**I. AMENDMENTS TO THE DRAWINGS**

Fig. 16

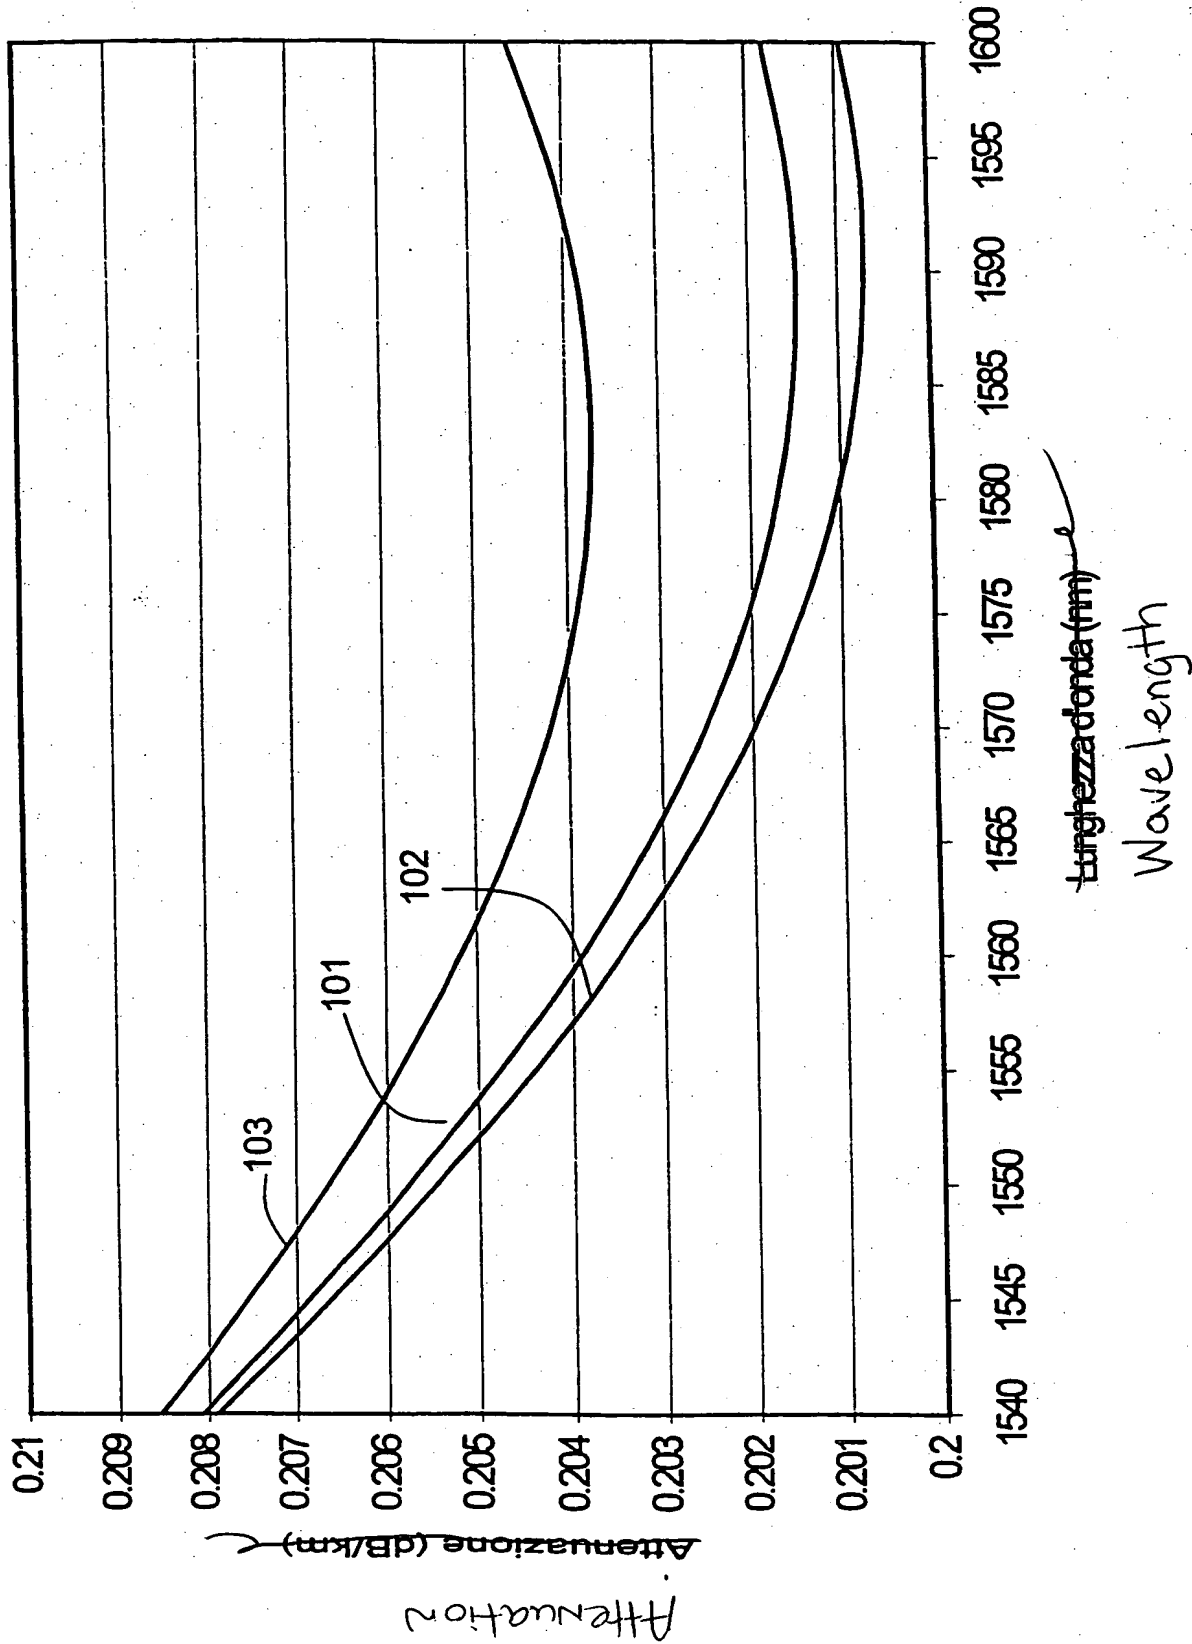
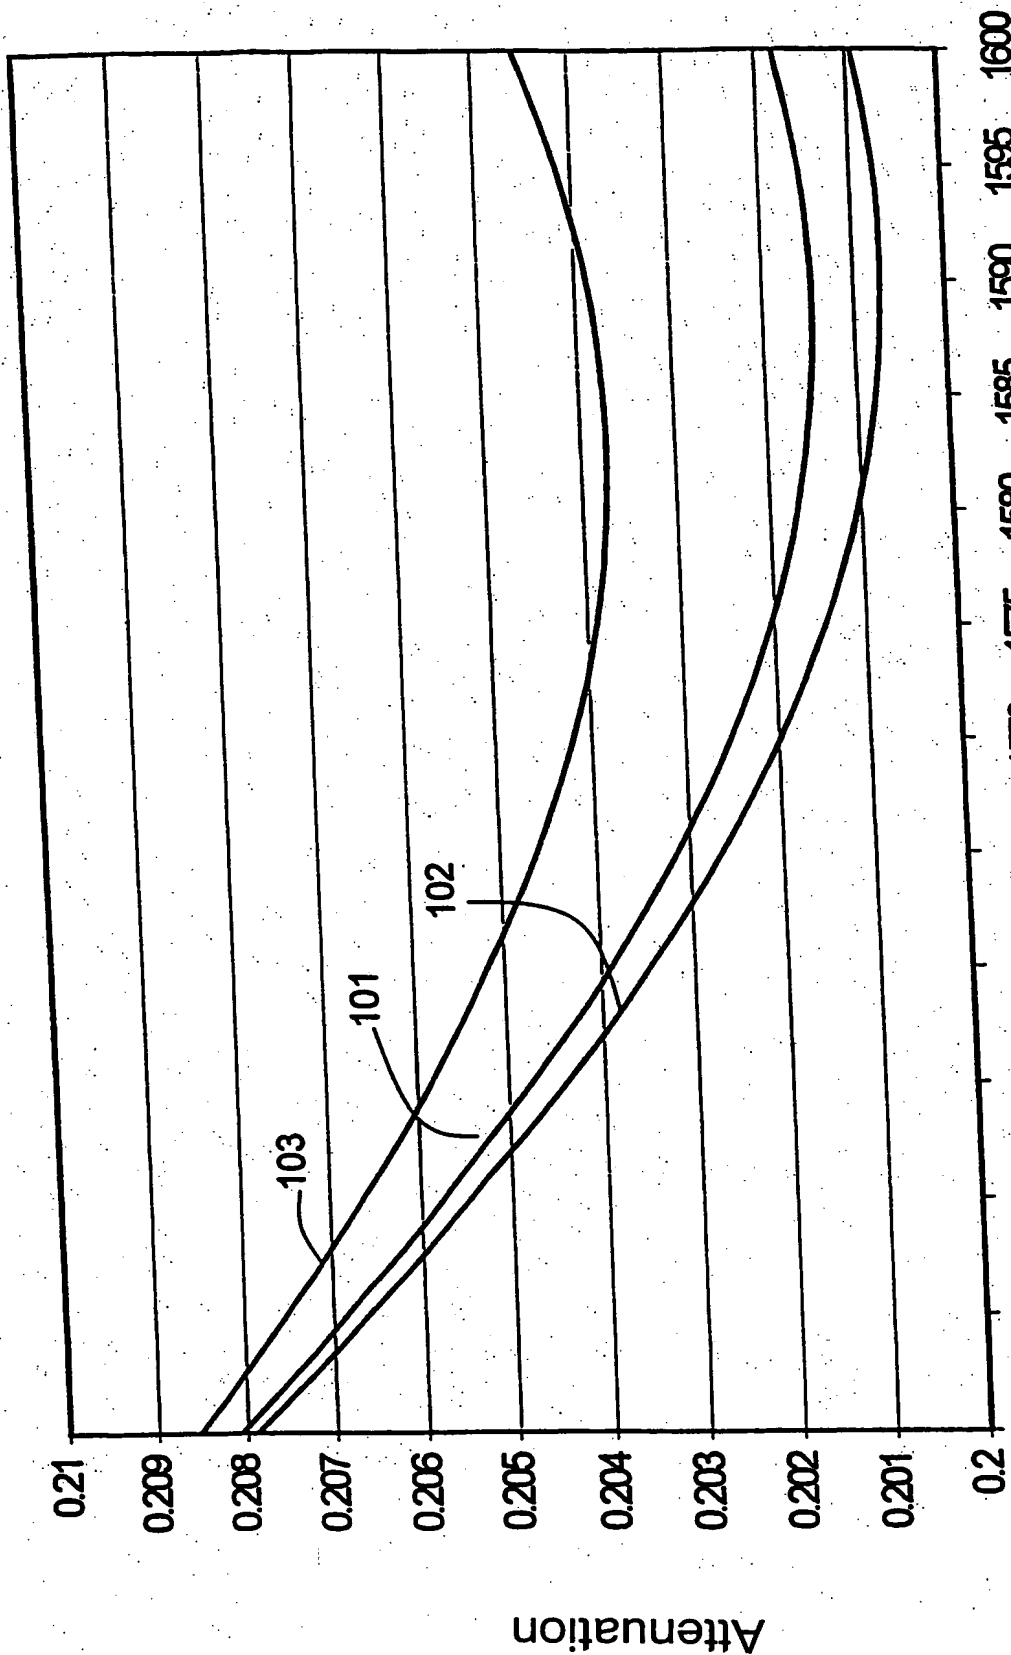
Figure 16 has been amended as shown on the follow Amended Sheet and Replacement Sheet of Fig. 16, by changing the horizontal axis label to "Wavelength" and changing the vertical axis label to "Attenuation."
